RECALL

R26AB: All Weather Wiper Blade Loose Nut

Models Affected: Certain model year 2026 - 2027 All American School and Non-School Buses

Diagram A

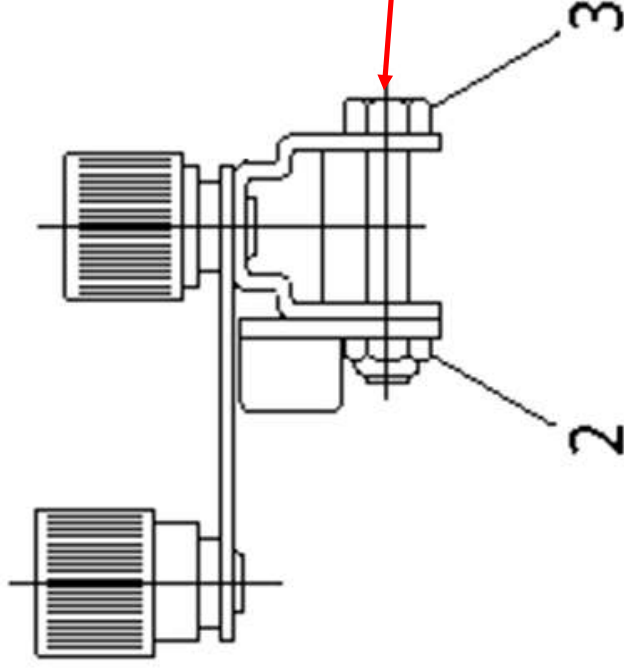
Issue: Certain 2026 - 2027 All American School and Non-School Buses may experience loose securing nut on the all-weather wiper blade assembly.

Corrective Action: Inspect for loose securing nut by checking that torque on the nut is at 8-10 ft-lbs. (11-13 Nm). If unable to set torque due to damage or missing nut, then replace with listed parts and torque fastener to 8-10 ft-lbs. (11-13 Nm).

1. Remove and install new saddle nut (2) and bolt (3) as required and set torque to 8-10 ft-lbs. (11-13 Nm)
